V-6 POWER TRIM MOTOR HARNESS

Models Affected

MERCURY/MARINER
135 THRU 250 HP CARB/EFI/OPTIMAX
0G303046 THRU 0G803202

Advisory

- a - Power Trim Harness
- b - Conduit P/N 32-828547353
- c - Sta-Strap P/N 54-816311

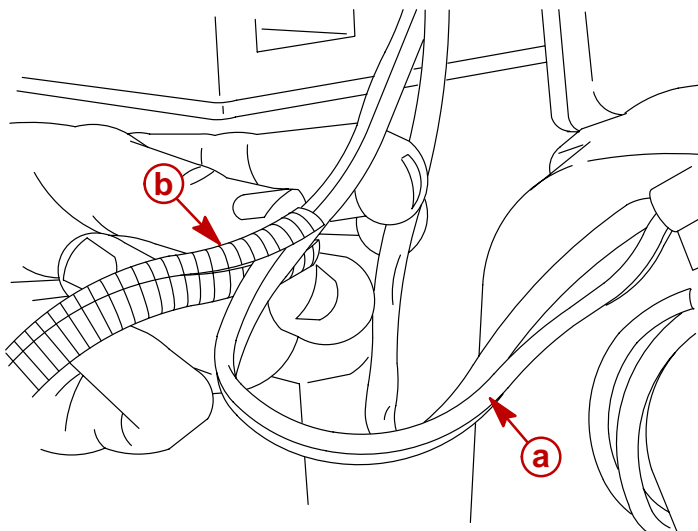
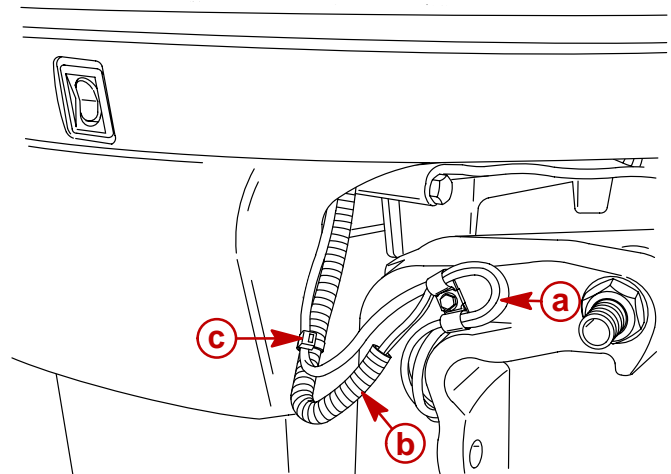
In some isolated cases contact between the power trim motor harness and the bottom cowl has been reported by our Technical Account Managers. This condition over time could cause chaffing of the motor harness. When servicing outboards within this group, it is recommended conduit **P/N 32-828547353** be installed over the motor wires between the adapter plate and starboard clamp bracket. This will provide added protection against chaffing. **DO NOT** include the trim sender wire within the protective conduit. Sta-strap the conduit to the trim sender wire.
